Well Name: COTTON DRAW UNIT	Well Location: T25S / R32E / SEC 4 / NENE / 32.1651975 / -103.673281	County or Parish/State: LEA / NM
Well Number: 73	Type of Well: OIL WELL	Allottee or Tribe Name:
Lease Number: NMNM054031	Unit or CA Name: COTTON DRAW DELAWARE A	Unit or CA Number: NMNM70928B
US Well Number: 3002522882	Operator: CHEVRON USA INCORPORATED

Notice of Intent

Type of Submission: Notice of Intent	Type of Action: Workover Operations
Date Sundry Submitted: 01/15/2025	Time Sundry Submitted: 02:05
Date proposed operation will begin: 01/15/2025

PROPOSED
WELLBORE DIAGRAM

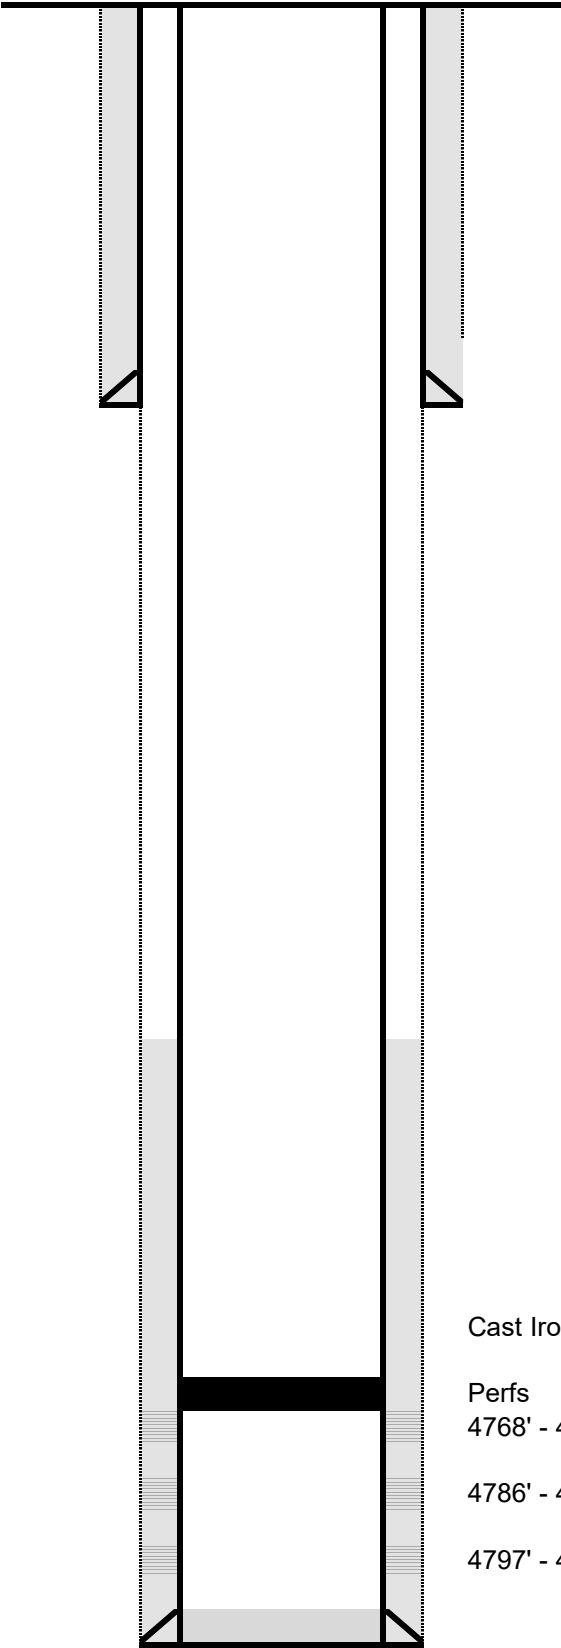
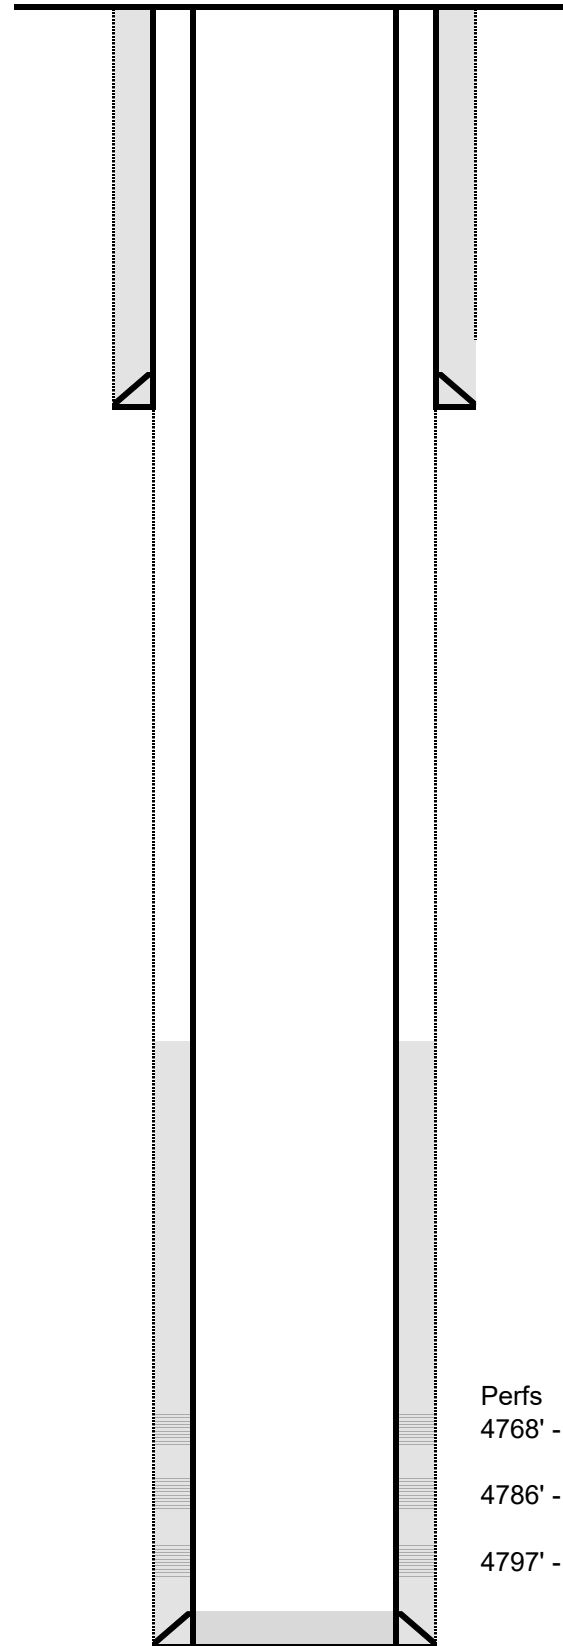
Contacted field specialist who notified team, and he let me know the Larkin head threads on this well were leaking gas. This thread is below our tubing hanger seal. They also excavated around the wellhead and found a shallow leak in the production casing. We are currently pulling rods and tubing while monitoring the well and would like to continue our request to set to CIBP so we can seal the gas migrating through our kill fluid. Once the CIBP is set we can repair the leak points and later file a C-103F for P&A.

Cast Iron Bridge Plug set at 4718'
